WESTTOWN TOWNSHIP

Re: Rezoning & Preliminary/Final Subdivision & Land Development Application
Westtown Woods – 15 lot residential development
1010 Wilmington Pike (UPI 67-4-9)

The Planning Commission has reviewed the preliminary-final plan for the Westtown Woods subdivision and recommends its approval by the Board of Supervisors subject to the following conditions:

PRELIMINARY/FINAL
PLAN AND PROFILE SHEET

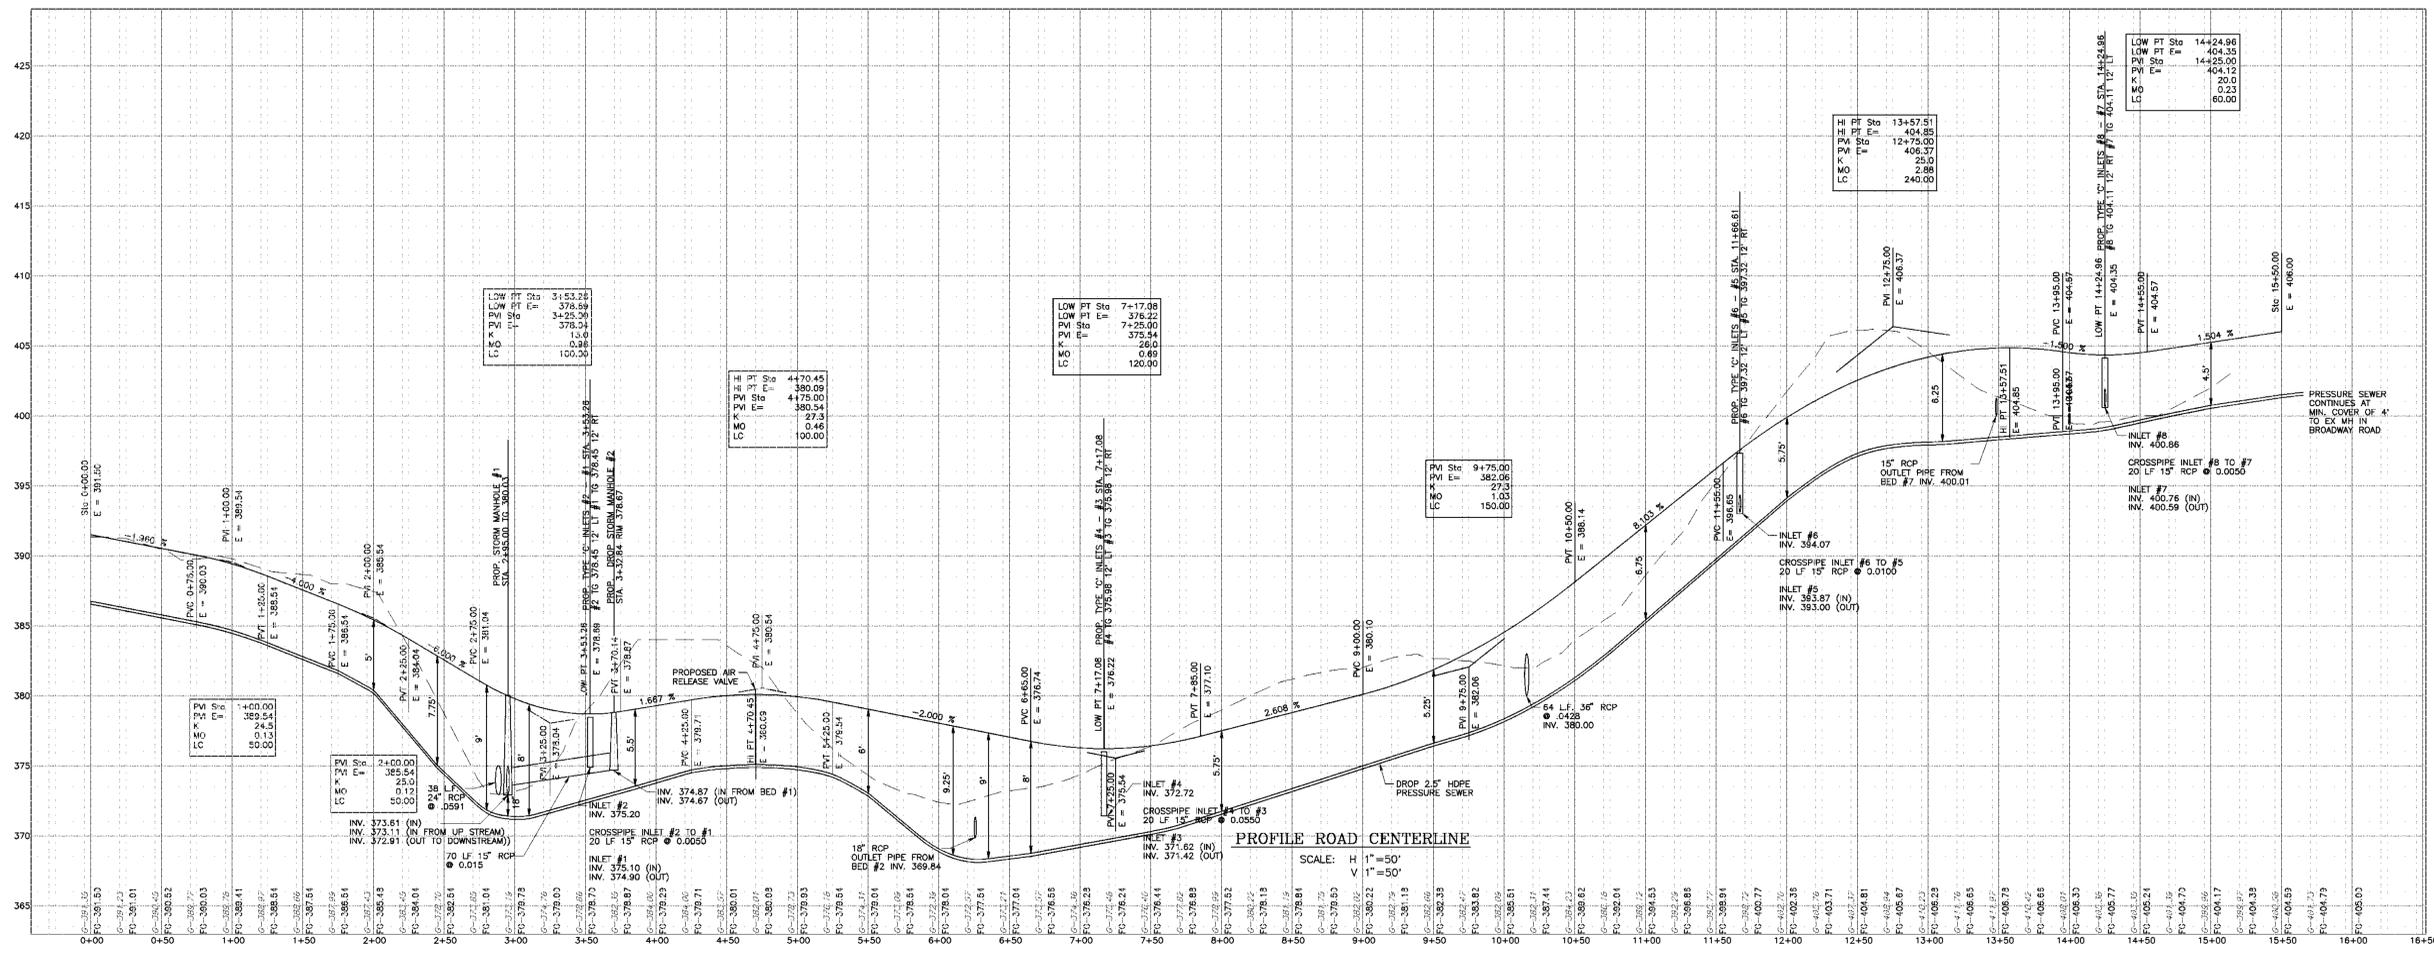
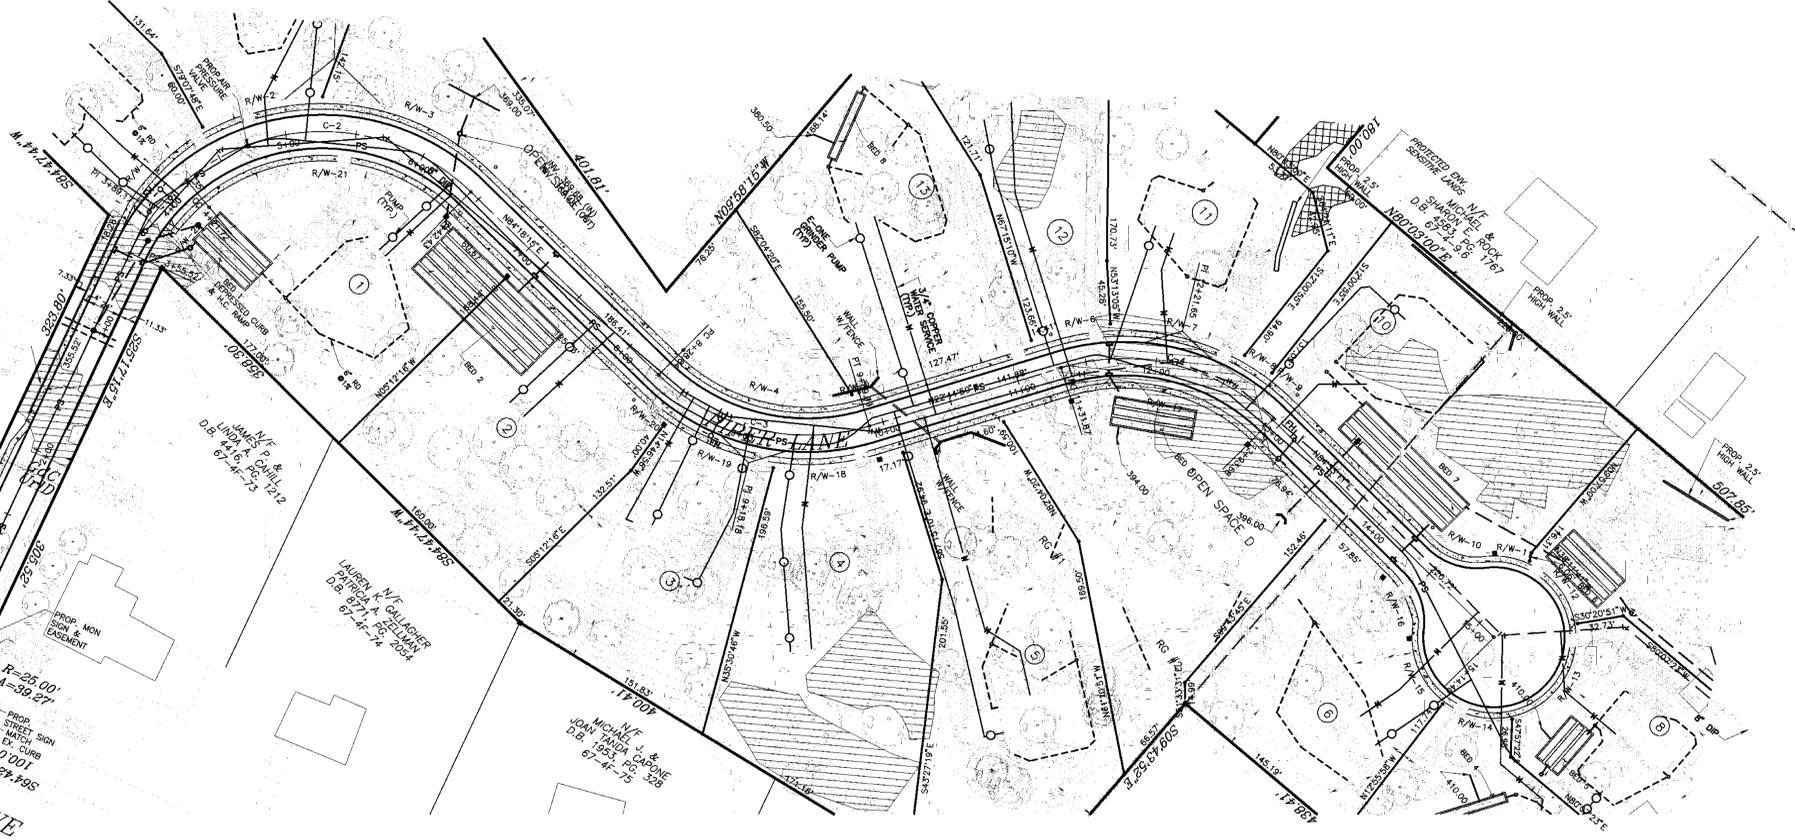
- *The Planning Commission recommends additional landscaping be required in the vicinity of the proposed wall associated with the road connection back to Jacqueline Drive as to serve as a vegetative screen.*

7	2-23-17	REVISED ENTRANCE ROAD WALL
6	2-6-17	REVISED PER CCDD COMMENTS OF 01-31-16
5	12-20-16	REVISED PER CCDD COMMENTS OF 11-23-16
4	11-29-16	REVISED PER TOWNSHIP ENGINEER'S COMMENTS
3	10-6-16	REVISED PER CCDD COMMENTS
2	9-27-16	REVISIONS PER ENGINEER'S COMMENTS OF 9-1-16 AND 9-2-16.
1	8-18-16	REVISIONS PER ENGINEER'S & TOWNSHIP STAFF REVIEW COMMENTS

Project-4062
 Date-3/17/16
 Scale-1"=50'
 Drawn-DB
 Checked-AE
 Sheet-8 OF 17

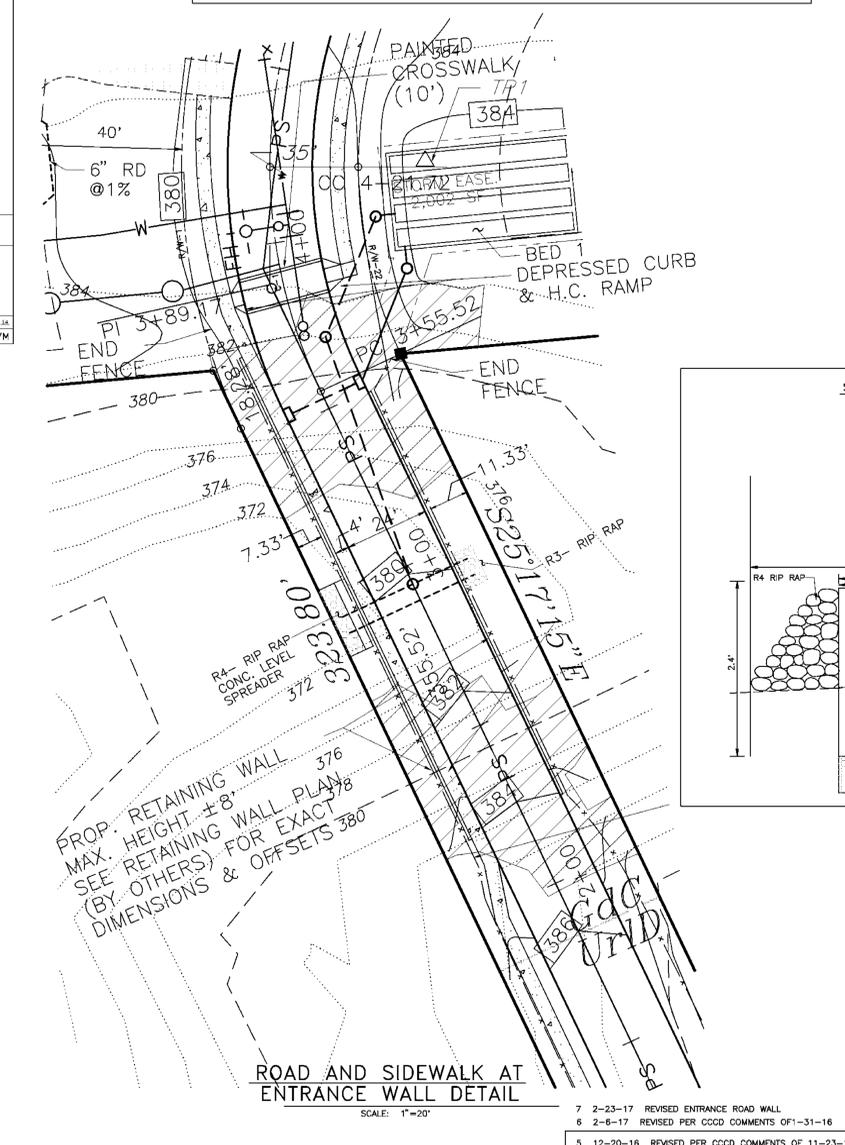
McCormick Taylor Response (12-02-2016): It appears that the applicant has revised the paving section to meet this requirement. However, the driveway section (Sheet 8) and flexible pavement restoration section (Sheet 5) still reference ID-2 and BCBC and should be revised.
